**ADDENDUM NO. 1**

**PROJECT NAME:** City Campus Central Utility Plant – 2<sup>nd</sup> Floor Addition  
**UNL PROJECT NUMBER:** C028P243  
**UNL INVITATION NUMBER:** 2298-14-7200

**DATE OF ISSUANCE:** Wednesday, January 29, 2014

The bid documents dated **12.20.13** for the above referenced project are amended by this addendum.

# G1.00

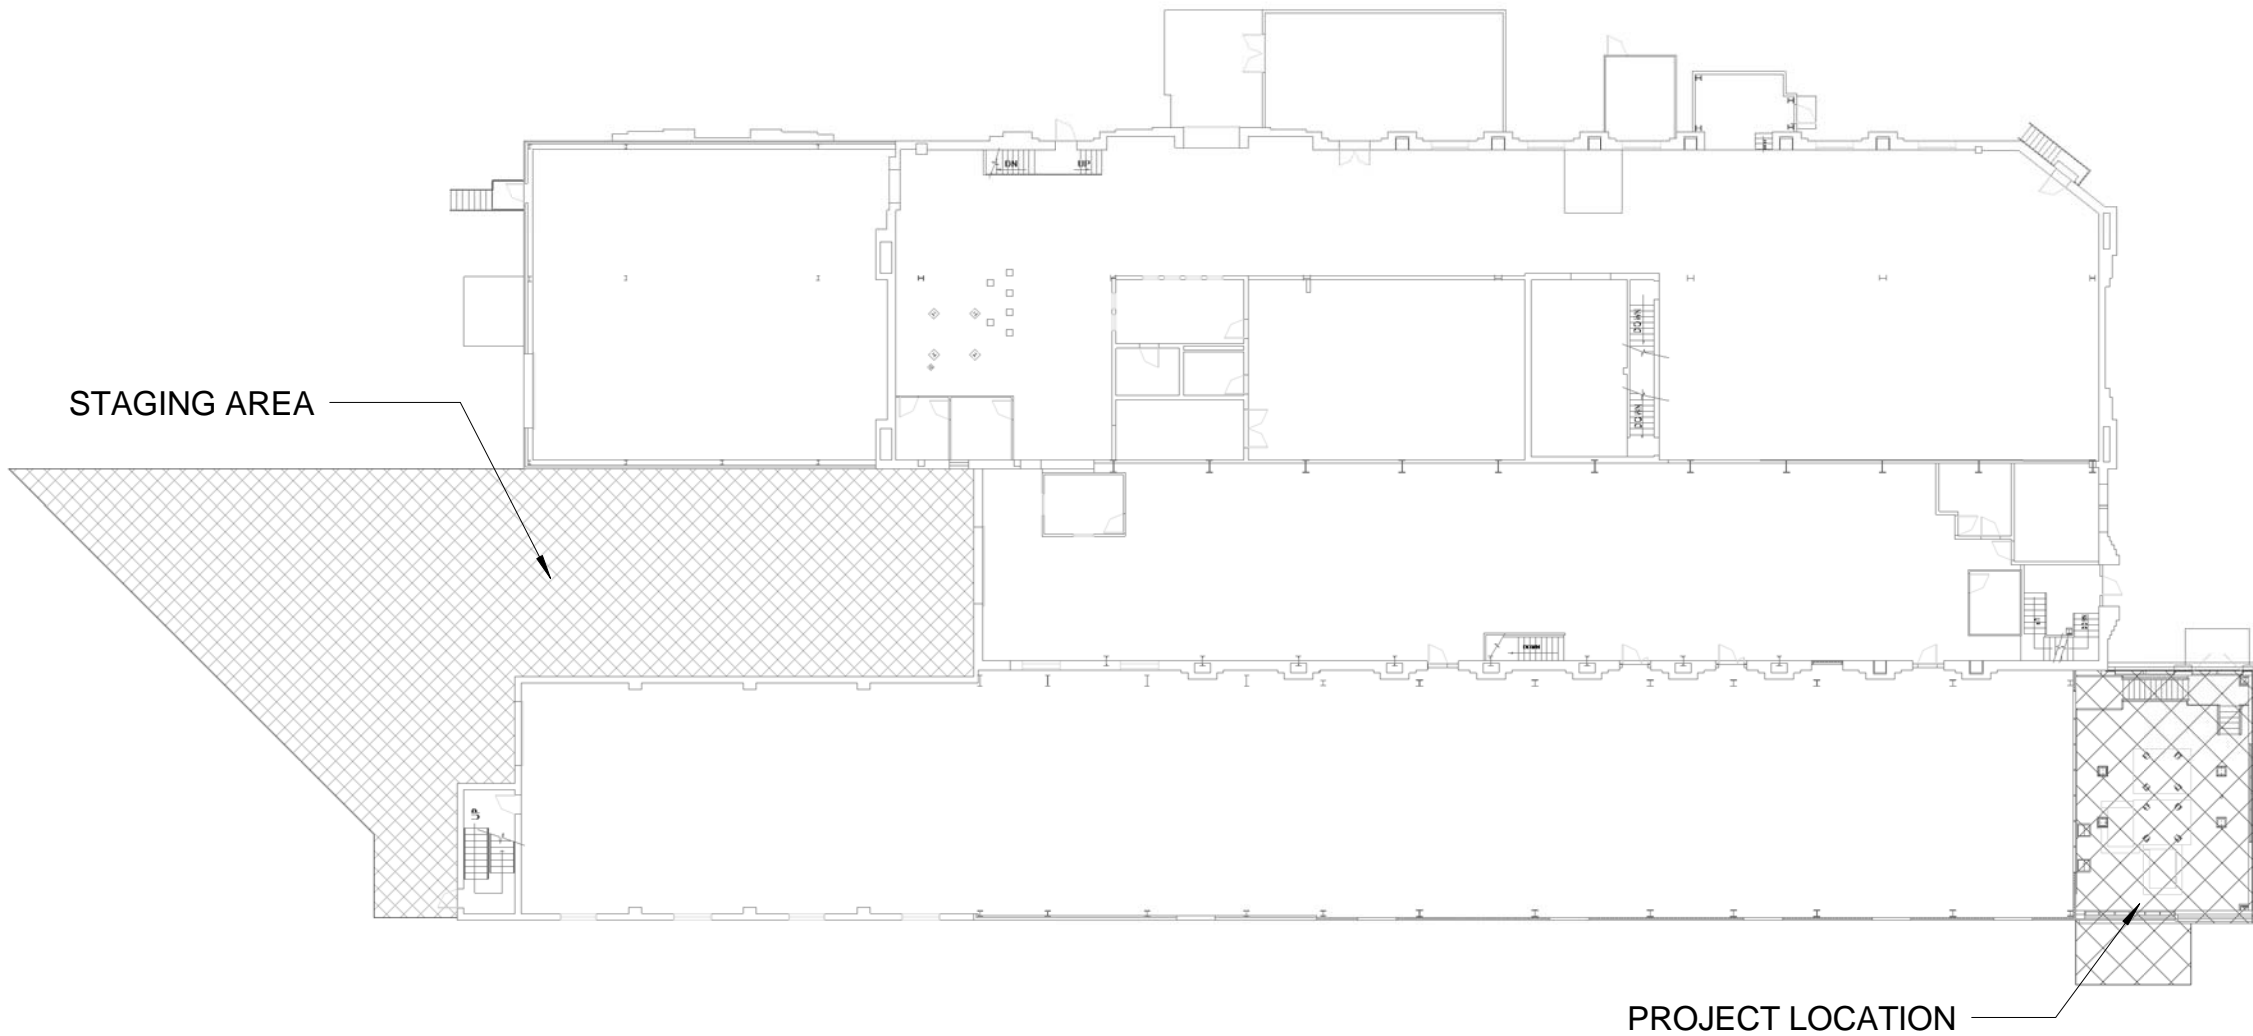
Sheet G1.00—Cover Sheet

1. Refer to Building Plan for Available Staging Area.

8  
A1.00

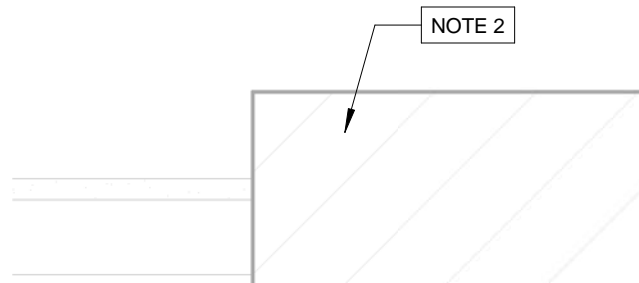
Sheet A1.02—Reflected Ceiling Plan & Details

1. Refer to Section Detail 8/A1.00. Additional layer of ½" plywood (2 total) per Specification Section 138400 will raise finished floor elevation of Second Floor to 121'-4".
